100/300 AREA UNIT MANAGER MEETING

100 & 300 AREA UNIT MANAGER MEETING MINUTES

June 11, 2009

100 D/DR AREA
FY08 REMAINING SITES REMEDIAL ACTION
CIVIL PLOT PLAN - 6: 128-D-2 & 100-D-7

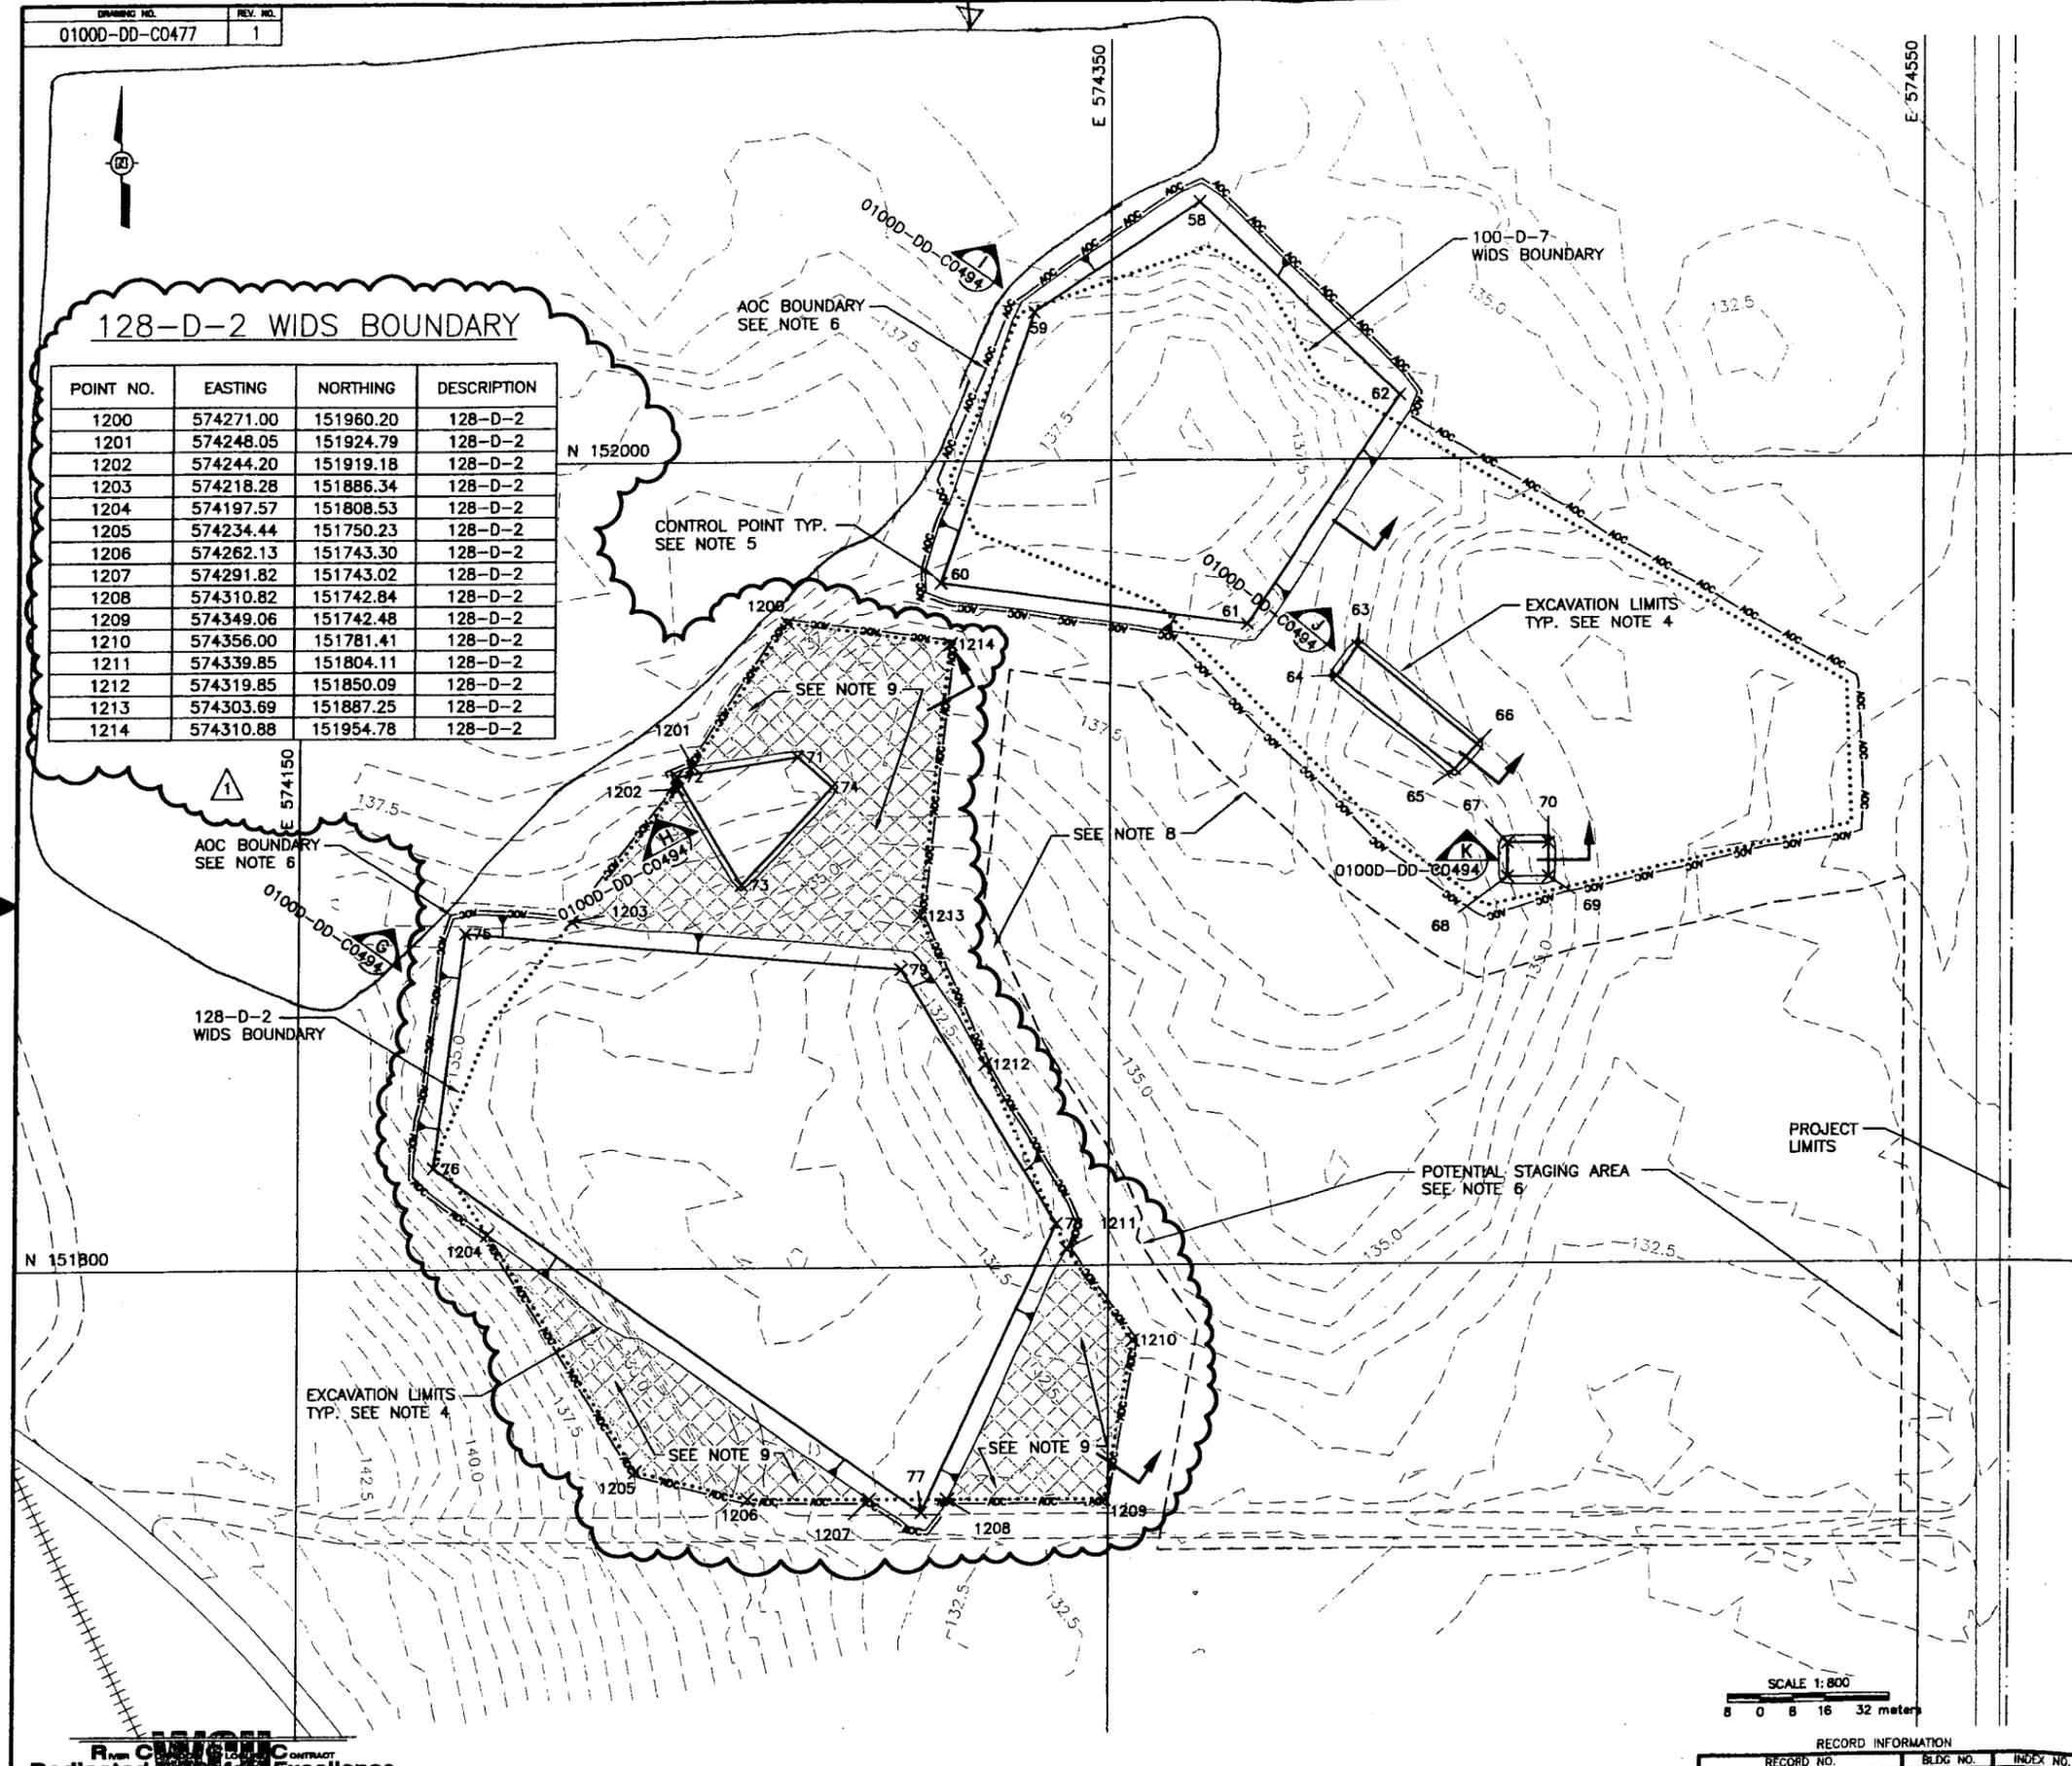
Ecology has reviewed WCH proposal for an additional staging pile area for the 128-D-2 & 100-D-7 sites. Ecology approves your suggested staging pile as previously identified on Civil Plot #0100D-DD-CO477. As stated in the Remedial Design Report/Remedial Action Work Plan for the 100 Area, DOE/RL-96-17, Rev 5, it is necessary for the staging pile to be operated in accordance with the substantive standards and design criteria prescribed in 40 CFR 264.554, paragraphs (d) thru (k). Also, it is Ecology's understanding that the staging pile will be subdivided in such a manner that wastes from the two sites will be segregated. With closure of the staging pile, all potential contaminants of concern and contaminants of concern for the contributing sites shall be carried forward into the cleanup verification sampling plan and the underlying areas sampled accordingly.

Please have this agreement captured in the 100/300 Area UMM minutes along with the civil drawing #0100D-DD-CO477.

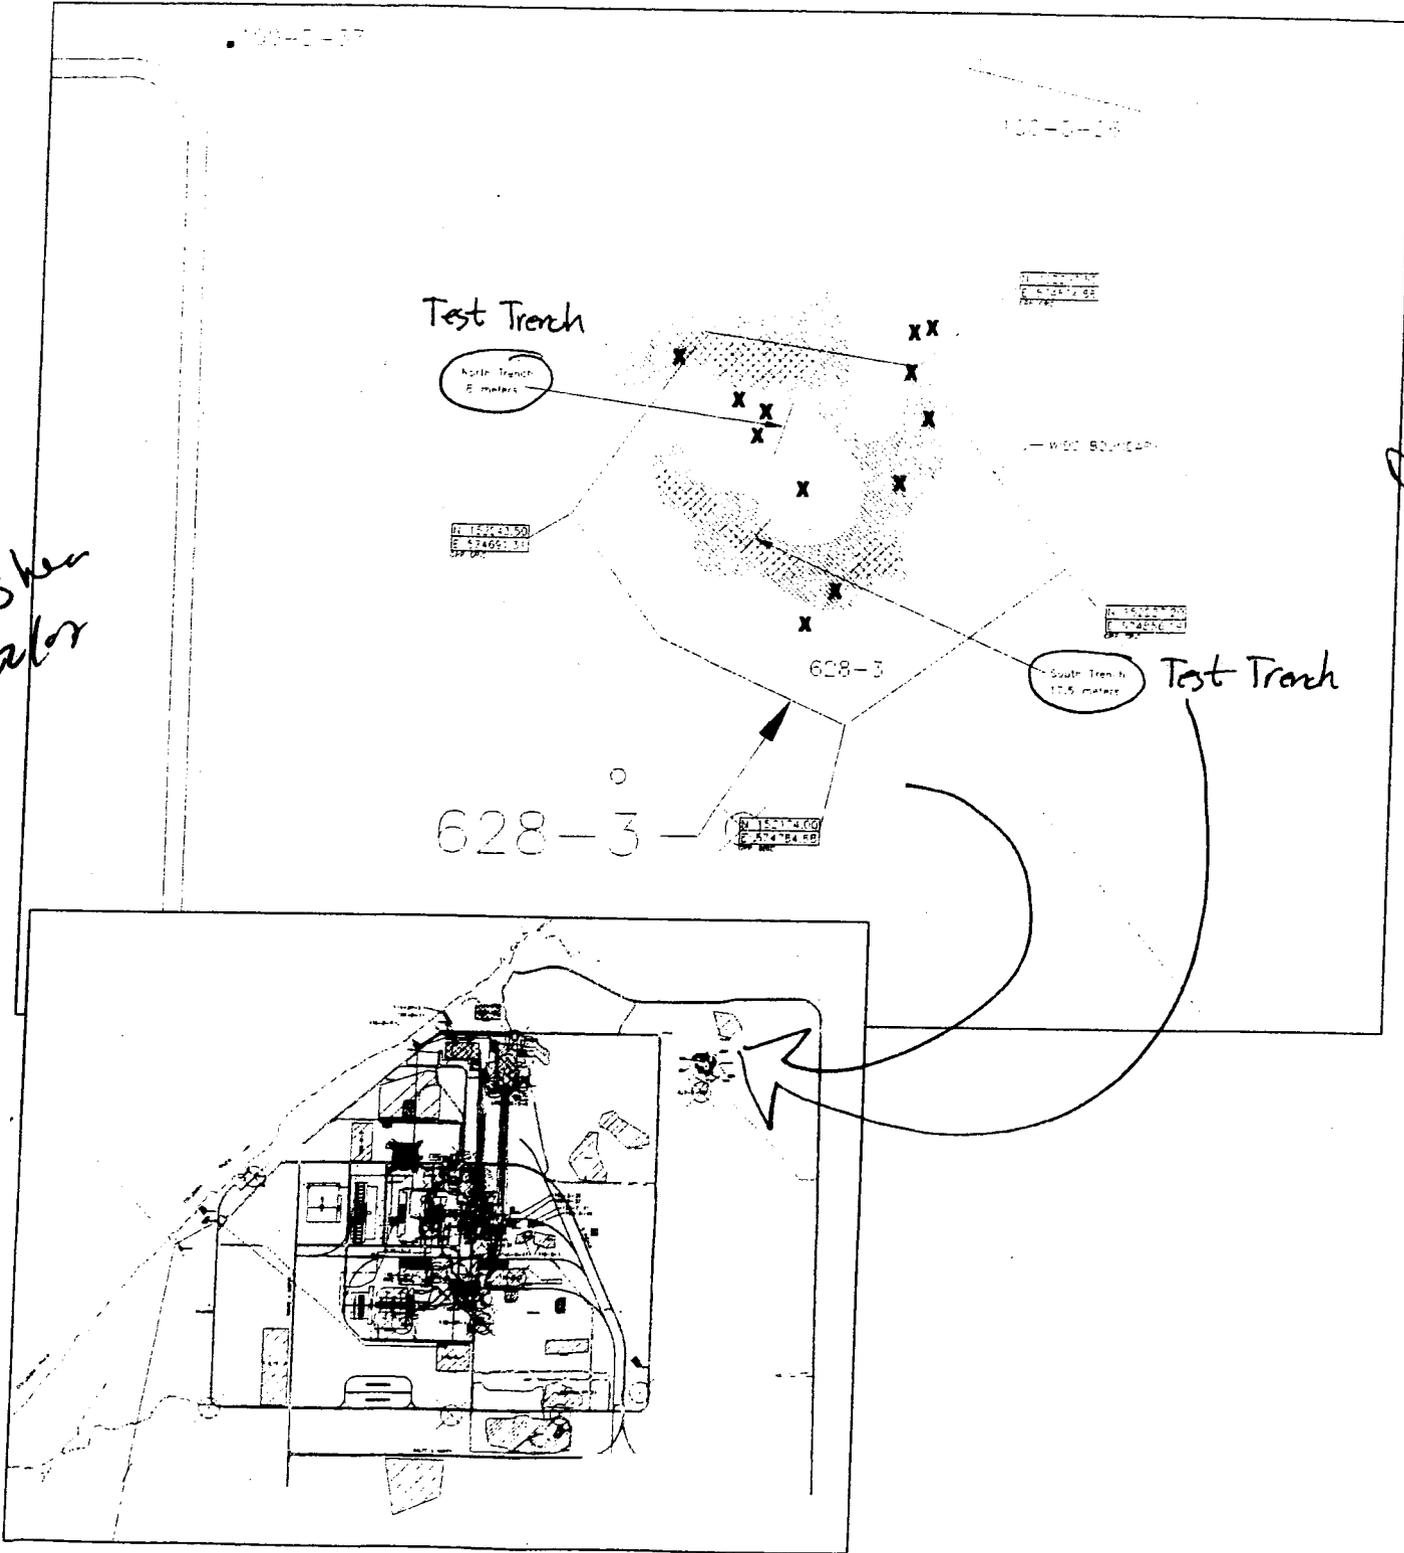
Ecology has reviewed your proposal to reduce the depth of the design for the 628-3 Burn Pit and additional information provided in the RTD Report. Ecology supports your request with the caveat that WCH will chase any debris or contamination to greater depths or outside the WIDs boundary (identified in Figure 2) as necessary.
